**Queensland Floods
Commission of Inquiry
Technical Review of Flood Frequency
Analysis Report by WMAwater (12
October 2011) on Ipswich Flood
Frequency Analysis**

Ipswich City Council

Prepared By: BMT WBM Pty Ltd (Member of the BMT group of companies)

Figure B-1 – Proportion of flows upstream of Ipswich for major contributing catchments

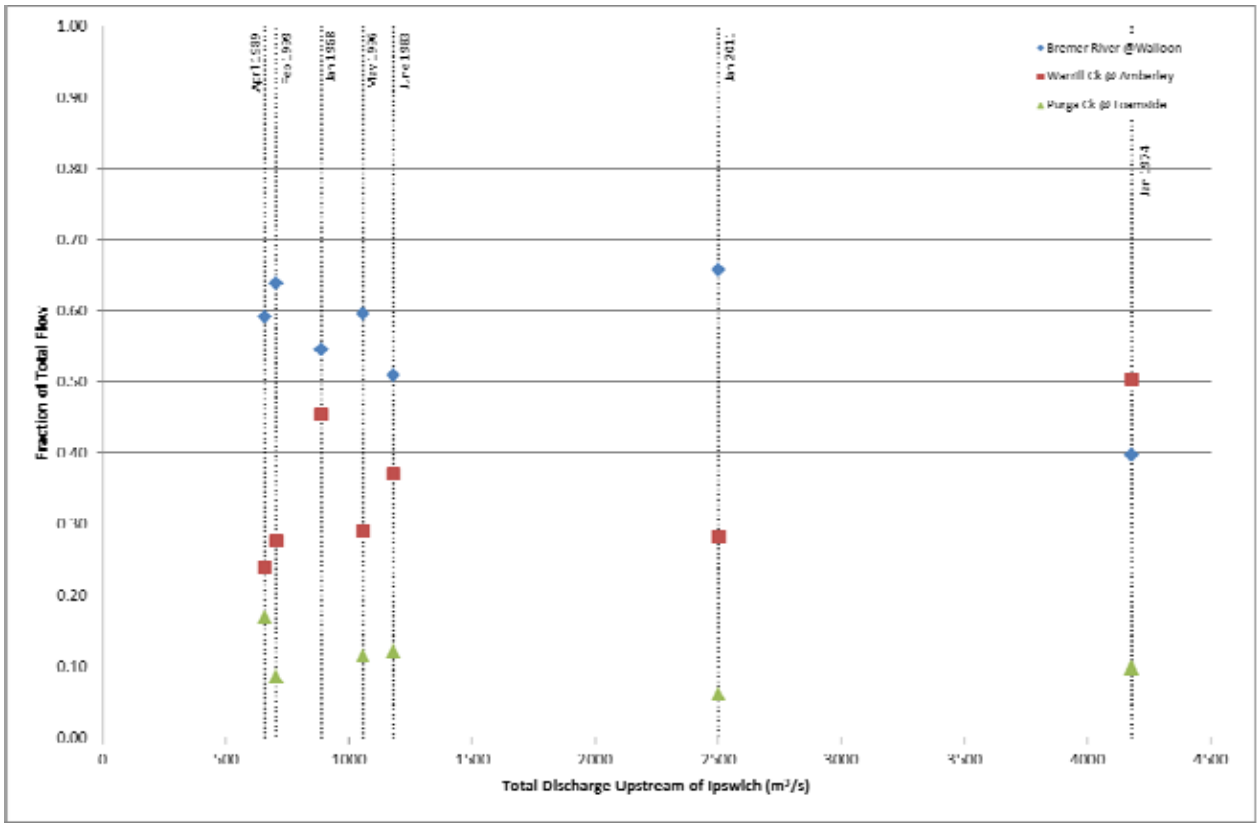
- The assumed catchment area relationship ($Q_{Amb} = 0.6 * Q_{Ips}$) does not correlate with the flow data for the various gauging stations upstream of Ipswich.
- The historical data suggests that (on average) flows are greater in the Bremer River catchment to Walloon than the Warrill Creek catchment to Amberley, despite having a smaller catchment area.
- Purga Creek has an average contribution of 10%-11% to the total flow upstream of Ipswich.

Figure B-2 – Flow hydrographs for January 2011 event

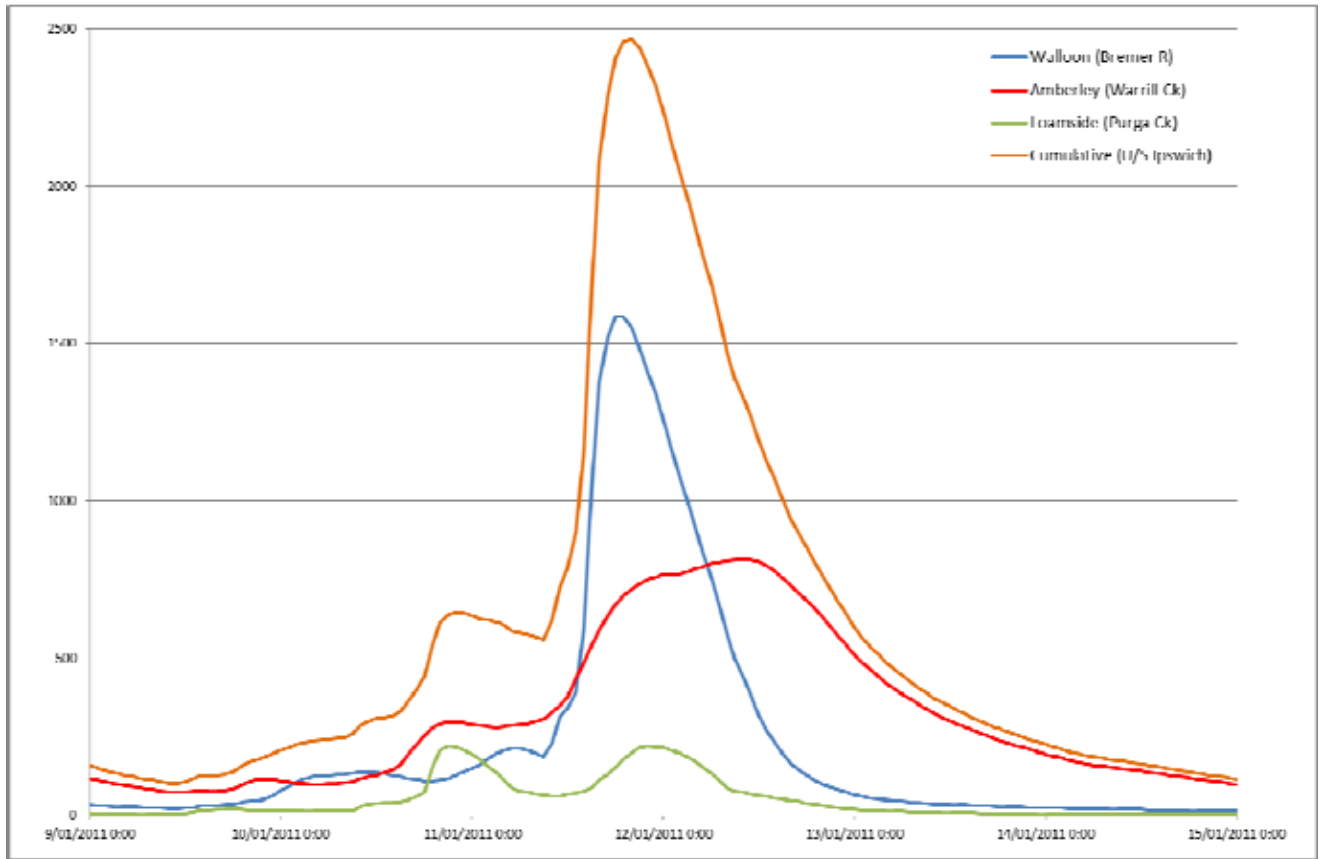
Flow hydrographs at the various gauges in the vicinity of Ipswich are given in Figure B-2 below. This shows that the majority of flow upstream of Ipswich is within the Bremer River catchment with a lesser contribution from the Warrill Creek catchment.

Figure B6: Contours of Ipswich flood level relationship with Q_{sav} and Q_{Amb}

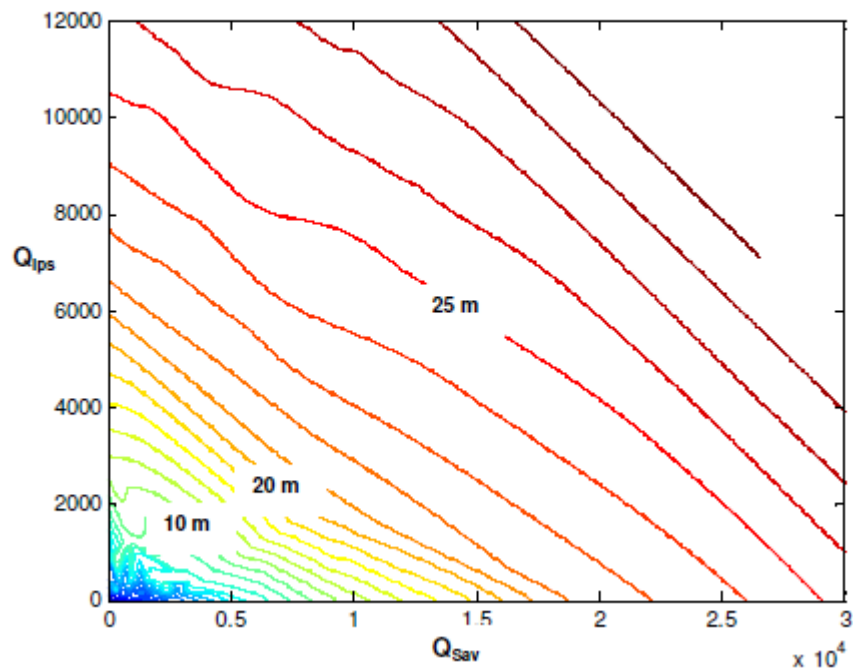
* Derived from Figure B6, WMA Water’s Supplementary Report - Ipswich Flood Frequency Analysis

Figure C1

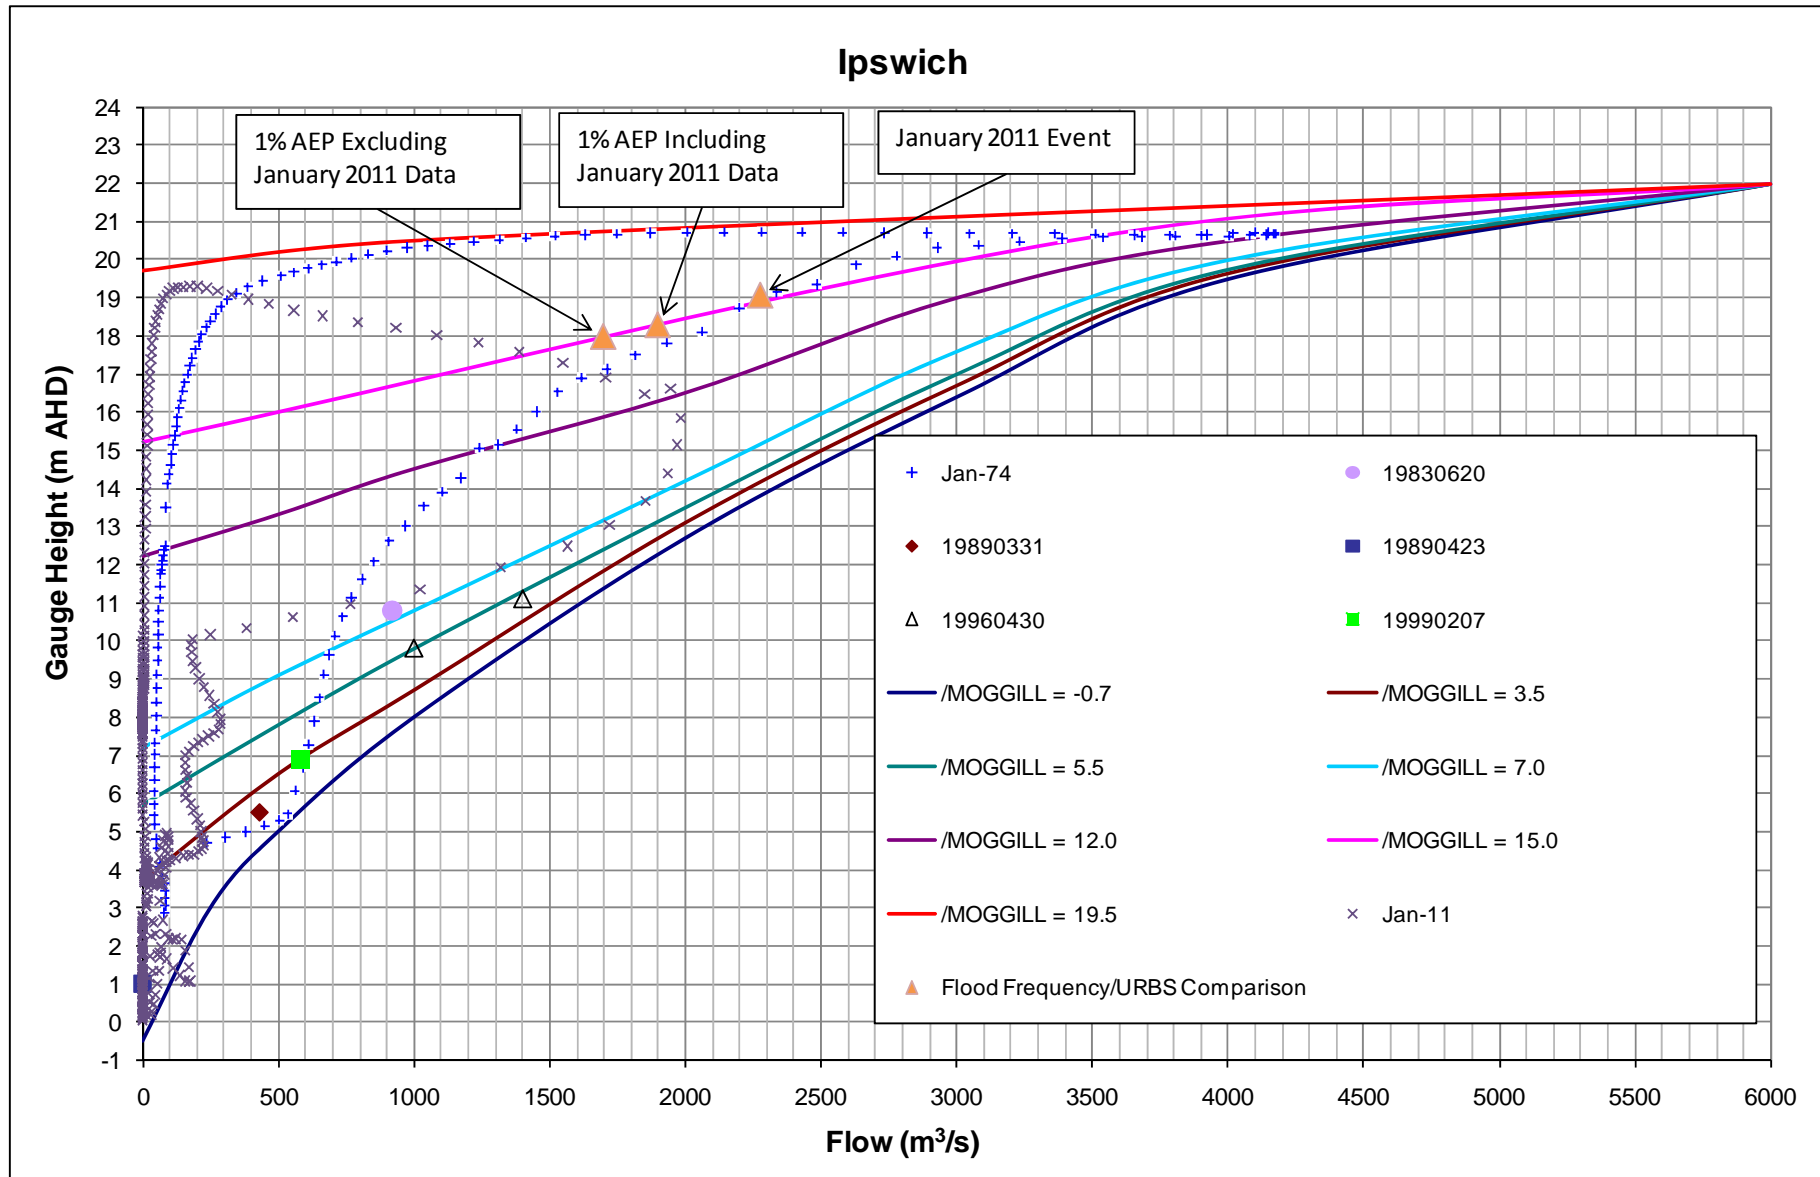
| | 1% AEP | |
|--|-----------------------------|-----------------------------|
| Peak Water Level (mAHD) (SEQWater’s Ipswich URBS rating– Refer Figure C1) | 18.0 | 18.3 |
